V2500-D5 SERIES PROPULSION SYSTEM SERVICE BULLETIN

This document transmits Revision 2 to Service Bulletin EV2500-72-0493 and Revision 2 to the Supplement

ENGINE - NUMBER 4 COMPARTMENT SCAVENGE ELBOW REDESIGN - MOD 72-0493**1. Planning Information****A. Effectivity**

LOCATION OF ELBOW GASKET AND LOCK
Figure 1

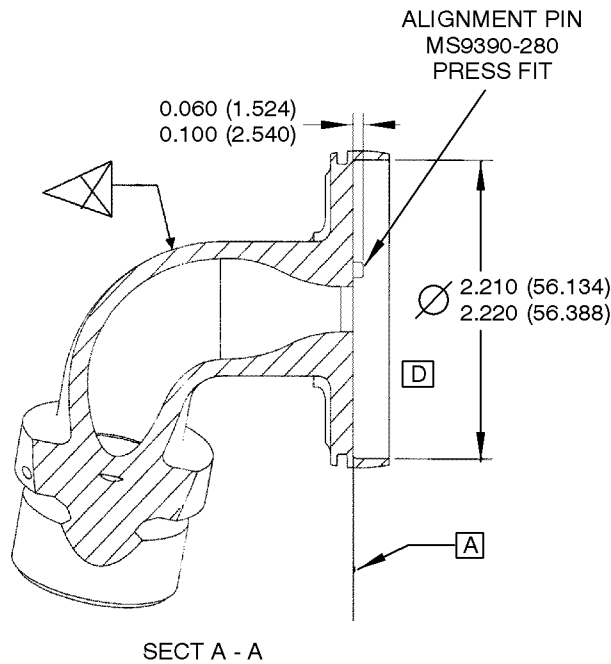
- (1) Replace the Elbow PN 2A2514, with a new Elbow Assy PN 2A3951-01 Containing Pin PN MS9390-280. Refer to engine manual Task 72-42-00-430-001 Subtask 72-42-00-430-067. See Figure 1.
- (2) Recording Instructions
 - (a) A record of accomplishment is required.

ELBOW ASSEMBLY
Figure 2

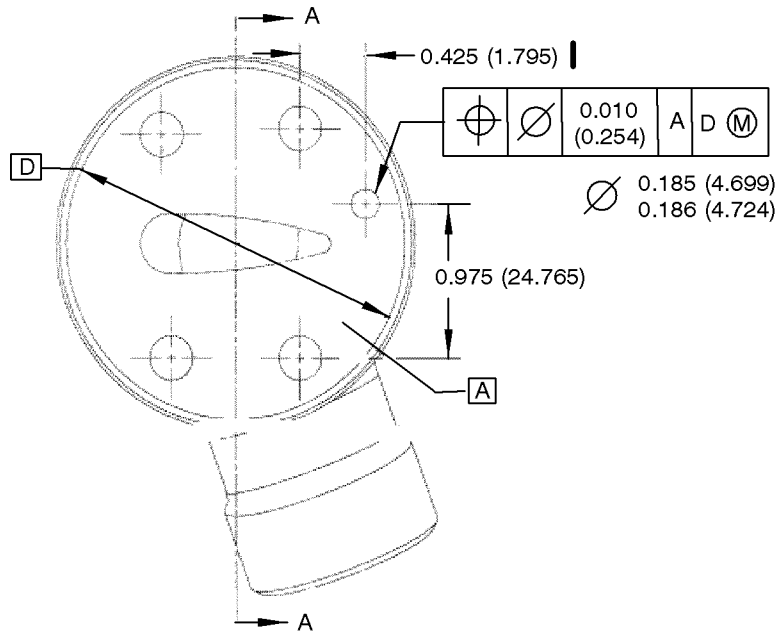
Remove	Incorporate	Reason for change
All pages of the Summary	Pages 1 to 3 of the Summary	Corrections to 3.(1)(d) and Fig.2
All pages of the Service Bulletin	Pages 1 to 10 of the Service Bulletin	Corrections to 3.(1)(d) and Fig.2
All pages of Appendix 1	Page 1 and 2 of Appendix 1	Corrections to 3.(1)(d) and Fig.2

- (ii) Inspect the Elbow per Task 72-42-20-200-109.
 - (1) Test for cracks on the Elbow. Use Penetrant inspection procedure 70-23-01-230-501.
 - (d) Machine an alignment pin hole 0.185 (4.699) – 0.186 (4.724) as specified in Figure 2.

- (ii) Inspect the Elbow per Task 72-42-20-200-109.
 - (1) Test for cracks on the Elbow. Use Penetrant inspection procedure 70-23-01-230-501.
 - (g) Press Pin PN MS9390-280 into the alignment pin hole. See Figure 2.
